HUXLEY, IOWA
WESTVIEW HEIGHTS
PRELIMINARY PLAT

We have reviewed the revised preliminary plat for Westview Heights and find it acceptable with the following comments:

PRELIMINARY PLAT FOR: WESTVIEW HEIGHTS
 HUXLEY, IOWA

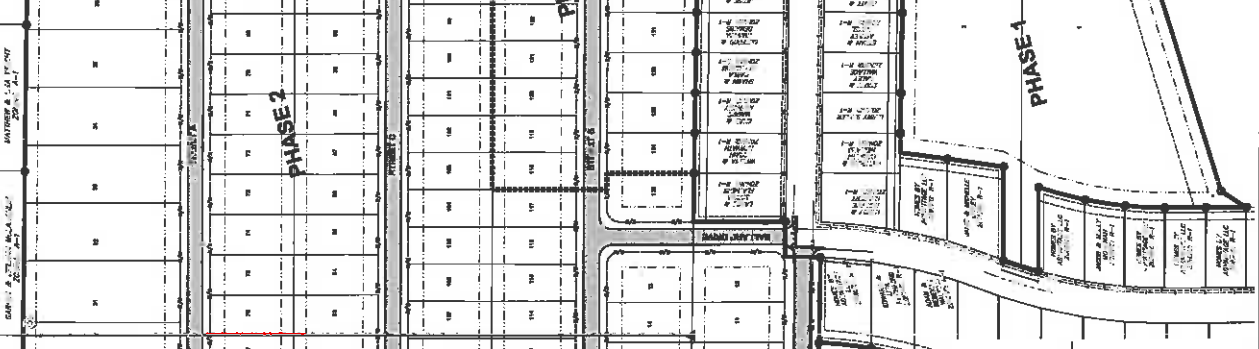
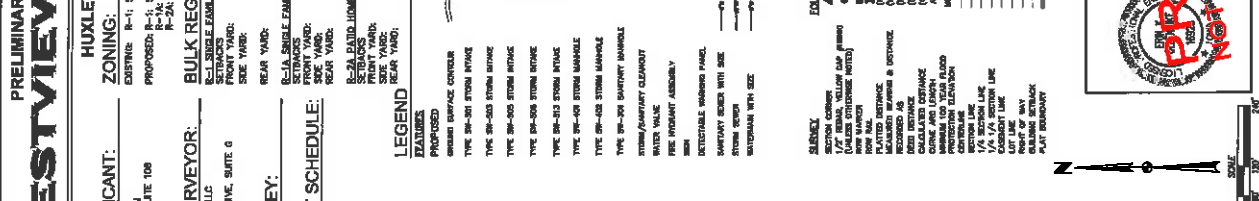
1. The installation of mid-block sidewalks running north and south through the middle of the plat needs to be evaluated. Planning and Zoning has recommended mid-block sidewalks not be installed.

2. The traffic study completed evaluating the impact of this development and a potential future development to the west of this plat show a second access onto Highway 69 is not warranted. Planning and Zoning has recommended two lots on the east side of Street A across from 310th Lane be reserved for a potential future second street access to Highway 69. The stormwater detention basin in this area will need to be adjusted to accommodate the potential second access.

3. The need for the street extension of the west Street A to the north plat boundary on the west side of the plat towards the west end of 306th Lane needs to be evaluated. Subdivision Ordinance 166.20.1 states "Streets shall provide for the continuation of major streets from adjoining platted areas, and the extension of major streets into adjoining unplatted areas." with major streets defined as an arterial, major collector, minor collector or local through street that has or is planned to have continuity to carry traffic from one section of the City to another. Planning and Zoning has recommended the street extension not be required.

4. The extension of sewer and water to the north plat boundary on the west side of the plat towards the west end of 306th Lane needs to be evaluated. Subdivision Ordinance 166.10.2 regarding sanitary sewers states, "Mains shall be extended to plat boundary where extension will be needed." and Subdivision Ordinance 166.10.4 regarding water mains states "Mains shall be extended to plat boundary where extension will be needed.". Planning and Zoning has recommended the utilities be extended.

5. The 8-inch water main needs to be extended to the east plat boundary in the northeast corner of the development for a future connection. Subdivision Ordinance 166.10.4 regarding water mains states "Mains shall be extended to plat boundary where extension will be needed.".

6. The lift station is proposed to be in a different location than as shown on the previously submitted preliminary plat to avoid a long access driveway. The lift station has been moved from the north end of Outlot Z to the south end of Outlot Z. The depth of the lift station will be increased approximately 14 feet by moving the lift station location. We estimate the depth of the lift station will need to be approximately 40 feet in order to provide sewer service for the north end of the development at the new location.

7. Backyard swales need to be installed at a minimum slope of 1.5% and at a target slope of 2%. If this slope cannot be obtained, a drain tile with surface intakes can be installed.

8. Centennial Drive is identified as a minor arterial in the comprehensive plan. Subdivision ordinance 166.21.7 states "Unless unavoidable, lots shall not front on or have direct access to arterial or major collector streets. Where unavoidable, lots shall be so arranged as to minimize the number of access points.". Lots obviously face Centennial Drive east of Ballard Drive. This subdivision provides for this practice to continue west of Ballard Drive.

9. A private oversized water main may need to be installed between Lots 1 and 2 for fire protection.
10. The proposed City Park is not proposed to occur until Phase 2.

11. The downstream sanitary sewer needs to be checked to make sure it has the capacity for the new development.

12. Easements between lots that will end up between residences should be a minimum of 30 feet wide.
13. An easement for a future water main extension needs to be shown on the west and south sides of Lot 1 to allow for a water main to be looped from the church to Ballard Drive through Lot 1.
14. A staged discharge structure needs to be evaluated if this would be more appropriate at the outlet for the northwest detention basin.
